Re: EER La Porte Recycling Center – Harris County  
Municipal Solid Waste (MSW) – Registration No. 40257 (pending)  
Registration Application – First Technical Notice of Deficiency (NOD)  
Tracking No. 14696576; RN105981062/CN603538240

Here are the comments in your letter dated July 19, 2011 and our response to each item:

Figure A-7 2/3  
PGM™ Reactor Foundation  
EER LaPorte Recycling Center  
LaPorte, Texas  
Tech-Revision #1 October 2011

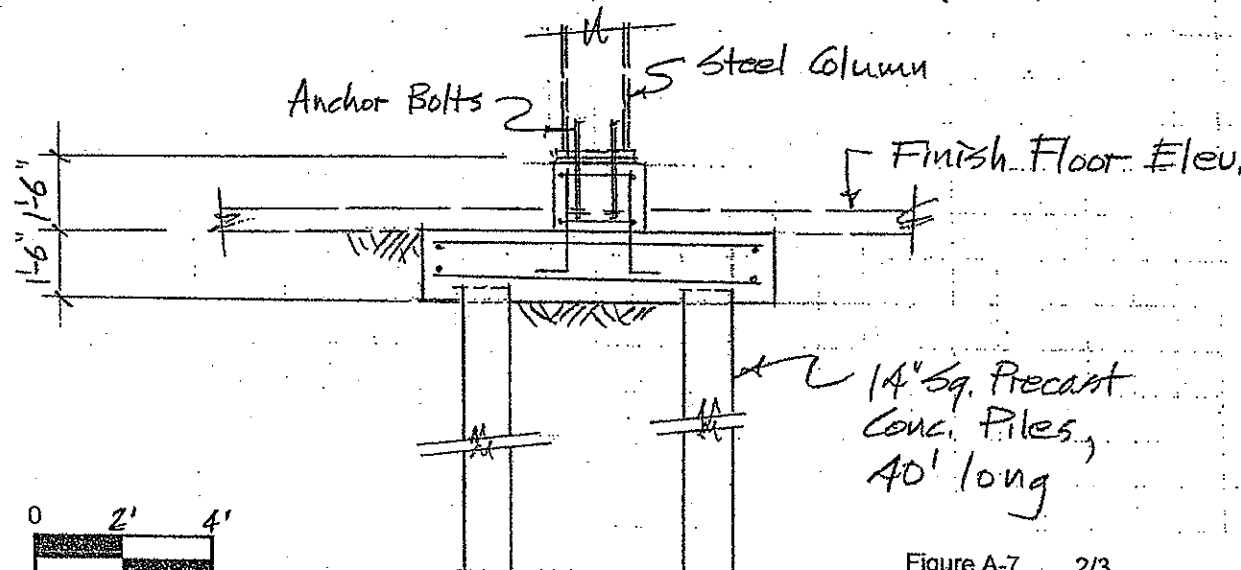
6. Section 2.E, page III-7, states “the slab under the Plasma Gasification Melting...will be determined during the detailed design phase of the project.” In accordance with 30 TAC §330.63(b)(E), please provide this information at this time.

**Response:** Section 2.E, page III-7, has been revised to include design information for the slab under the Plasma Gasification Melting vessel and the Thermal Residence Chamber. In accordance with 30 TAC 330.63(b)(E) which states that “generalized construction details of slab and subsurface supports of all storage and processing components” must be provided in the application, Figure II.G(3) and Figure II.G(4) in Exhibit F show the generalized foundation plan for the storage area and the Plasma Gasification Melting reactors, and Figure II.G(5), in Exhibit F shows a cross-section section of the slab. As per our discussion with Ms. Rambaud, the description and drawing of the foundation design in the application is a generalized construction detail of slab and subsurface supports of the Plasma Gasification Melting vessel and the Thermal Residence Chamber.

Figure II.D  
 Conceptual Plot Plan  
 EER LaPorte Recycling Center  
 LaPorte, Texas  
 Tech-Revision #1 October 2011

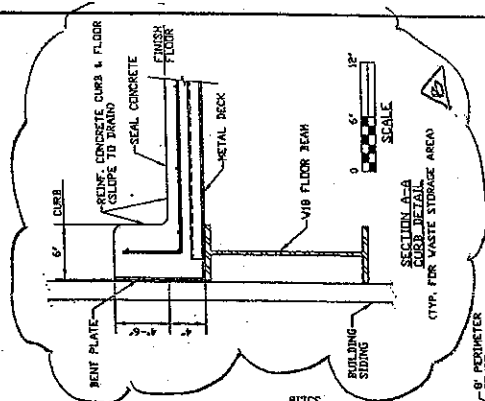
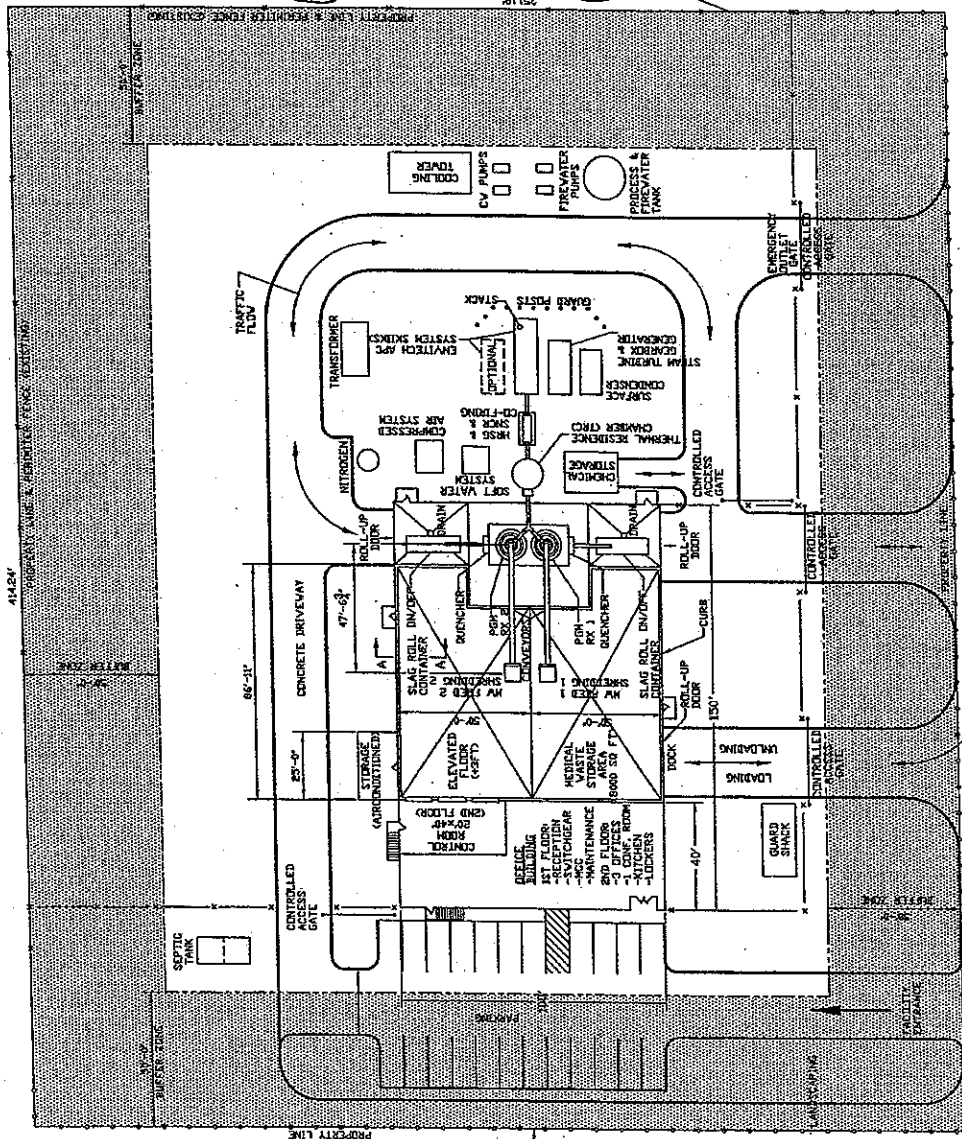
4. In accordance with 30 TAC §330.57(h)(4)(B) all drawings must have a bar scale at least one inch long. Please revise the following figures: A2-A7, ID, II.D (2 different scales are present on this drawing), E1-E3.

**Response:** The process water and firewater tank, which were actually noted on the right side of drawing II.D, is the source for the process and firefighting water stream. The well on the property will serve only as makeup to the tank as needed. We currently estimate the process and firefighting water tank to have a volume of 63,000 gallons which will be physically split in half within the tank so the fire fighting water cannot be used by the process. The physical division of the tank into two is so that the tank will keep water used for fire fighting physically separate from the water used in the process.

**Response: Figures A-2 through A-7, I.D, II.D, and Figures E-1 and E-2 have been revised and each now has a bar scale at least one inch long. Figures A-2 through A-7 are in Exhibit B; Figures E-1 and E-2 are in Exhibit B; Figure II.H is in Exhibit C; and Figure I.D is in Exhibit D. Figure II.D has 2 different bar scales for the following reason: a second inset figure with its own separate bar scale is included in Figure II.D to provide details on the curb construction specifications typical for the waste storage area. Figure E-3 entitled "Port Central SWQ Improvements, 10845 Strang Road, La Porte, Tx 77571" consists of five (5) diagrams illustrating plan views and cross sections with dimensions, construction materials, and other information about the storm water sewer grates, foundation, bedding, and backfill. As indicated in the captions to each diagram, these diagrams are not to scale; therefore, there are no bar scales shown in the diagrams.**

EER La Porte Recycling Center, FEMA Flood Insurance Rate Map

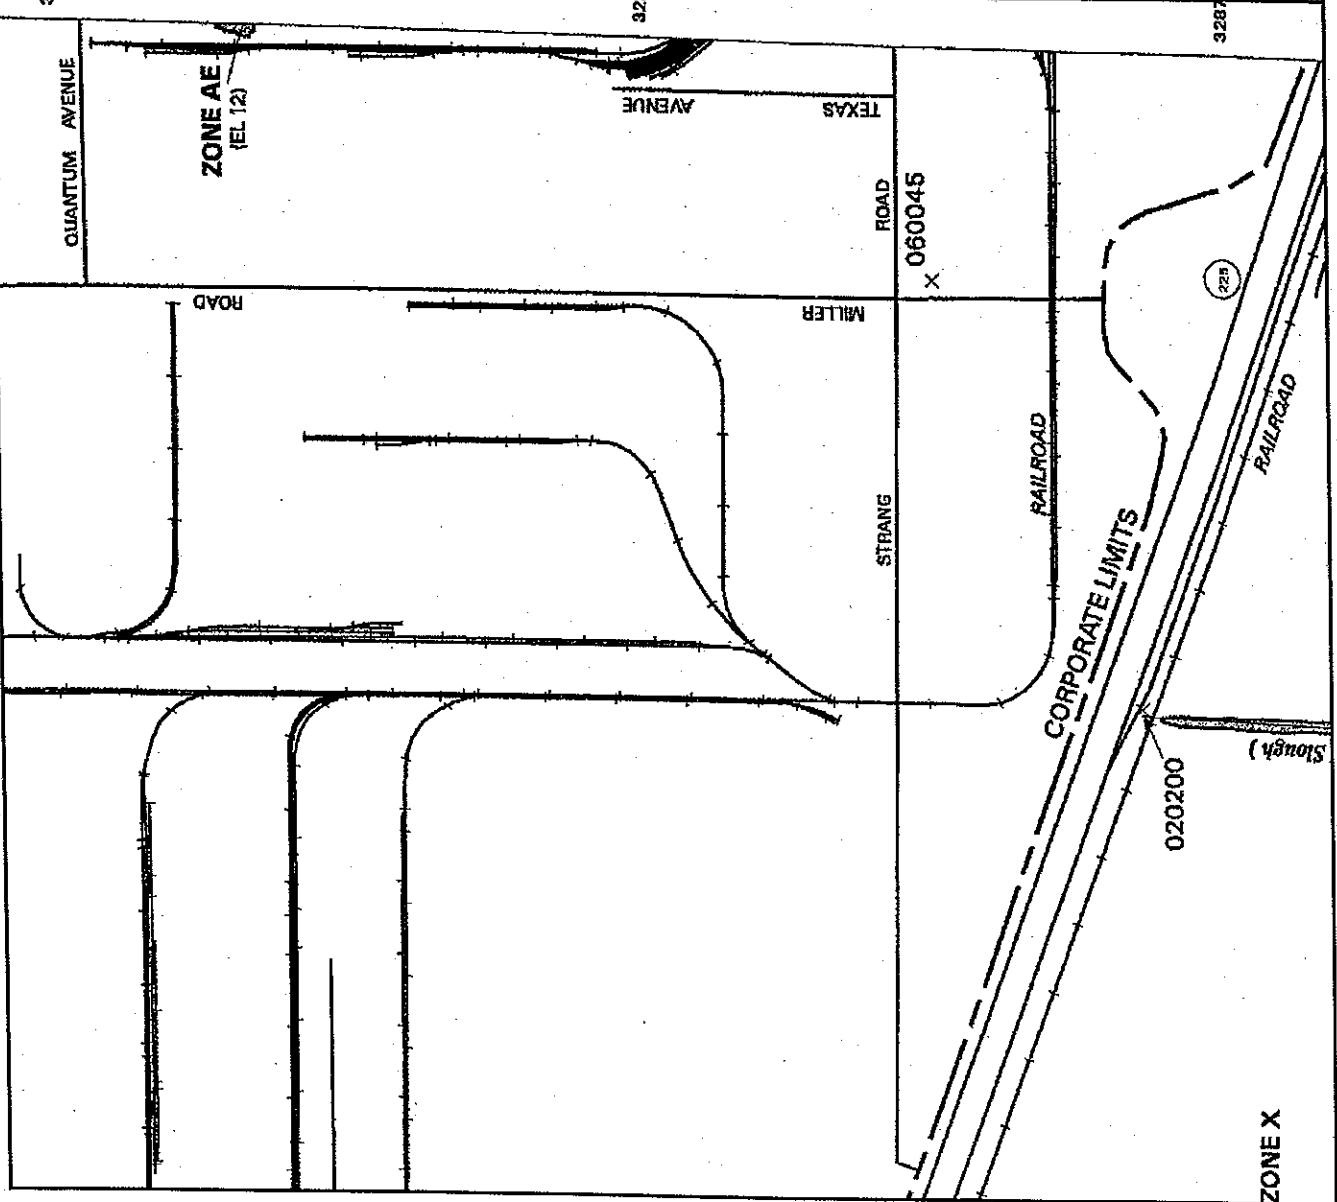
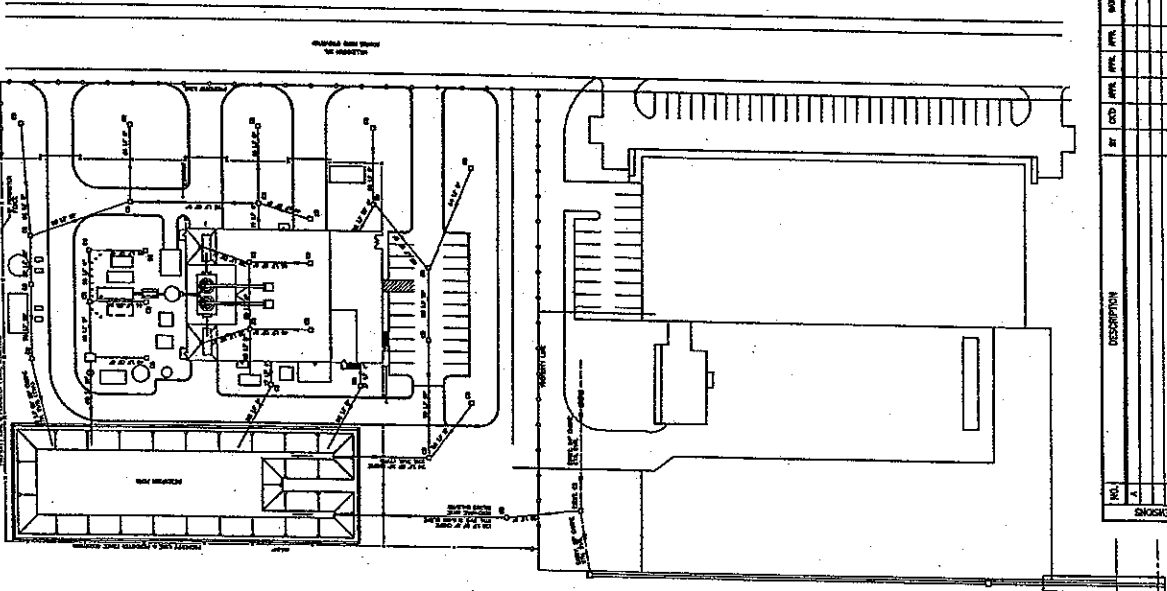
5. In accordance with 30 TAC §330.57(h)(5)(A) all drawings must have a north arrow. Please revise figures ID and FEMA Flood Insurance Rate Map of Attachment C.

**Response: The FEMA Flood Insurance Rate Map in Exhibit B and Figure I.D in Exhibit D have been revised so that each has a north arrow.**

**Figure II.H(1) - Published Zoning Map**

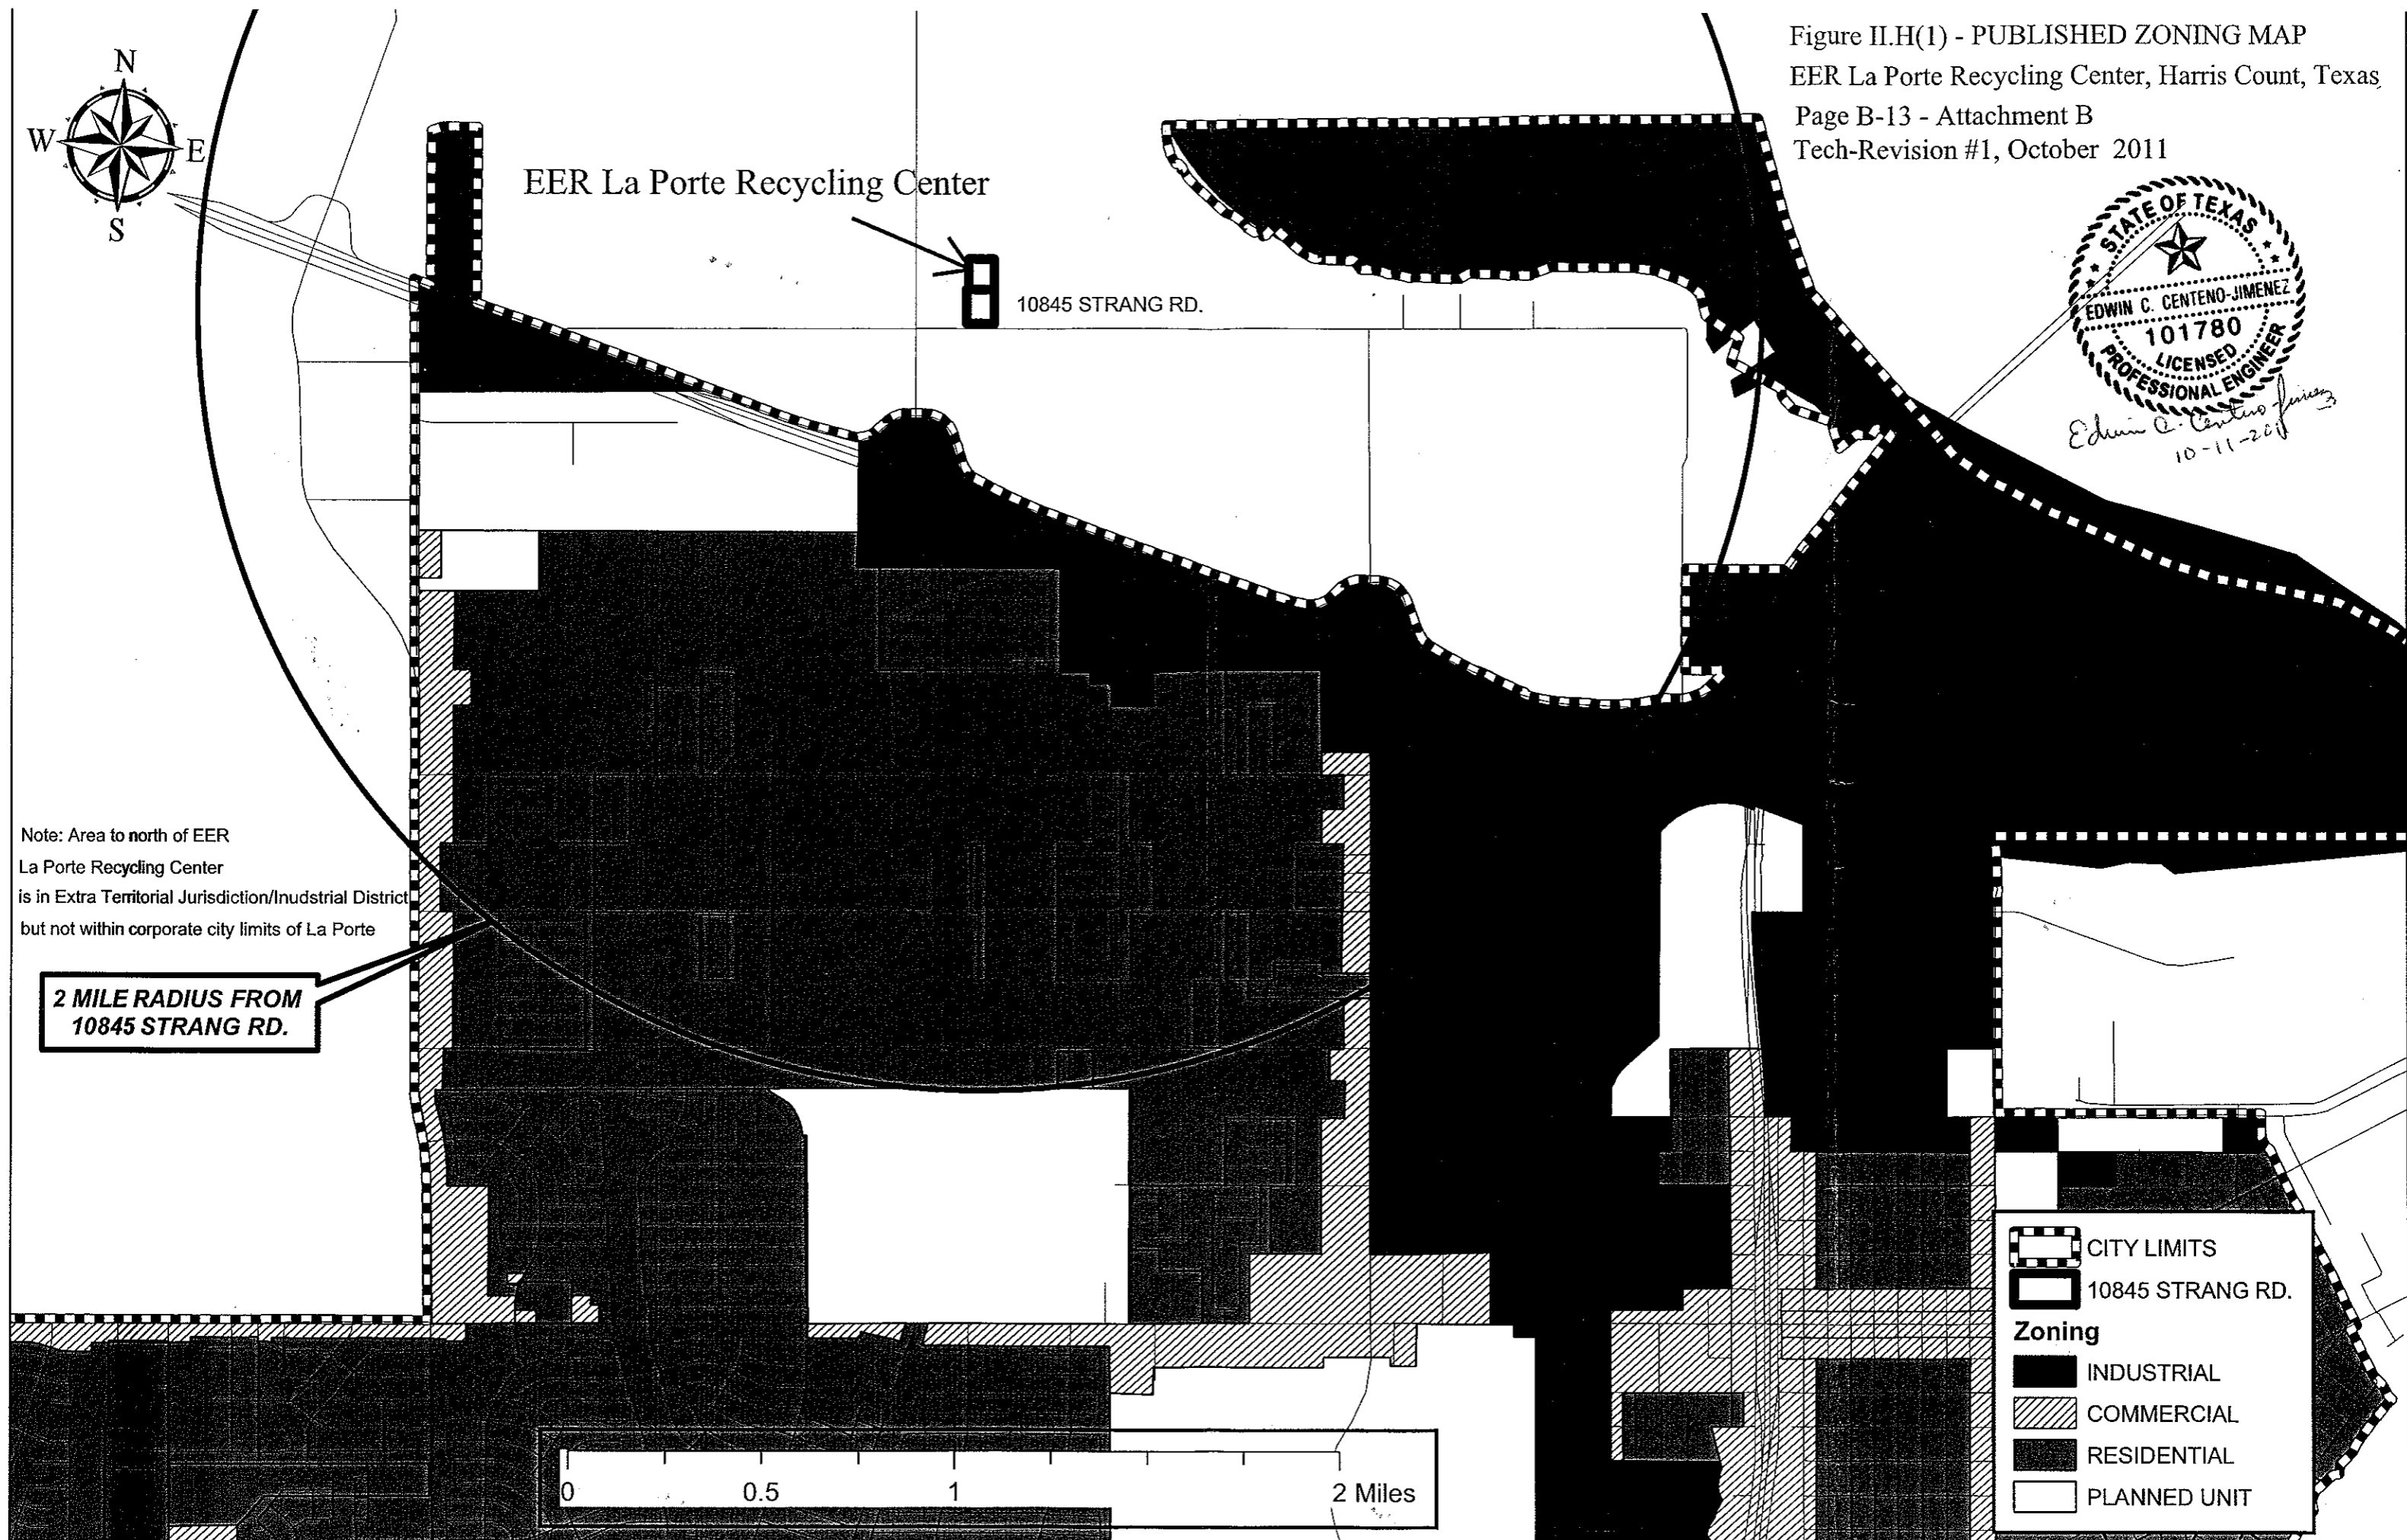
3. In accordance with 30 TAC §330.57(h)(2), color coding on drawings must be distinct when reproduced on a black and white photocopy machine. Figure II.H(1) Published Zoning Map, is not legible after copying in black and white. Please resubmit a legible copy.

**Response: A legible copy of Figure II.H(1) entitled Published Zoning Map has been prepared and is included as Exhibit C.**
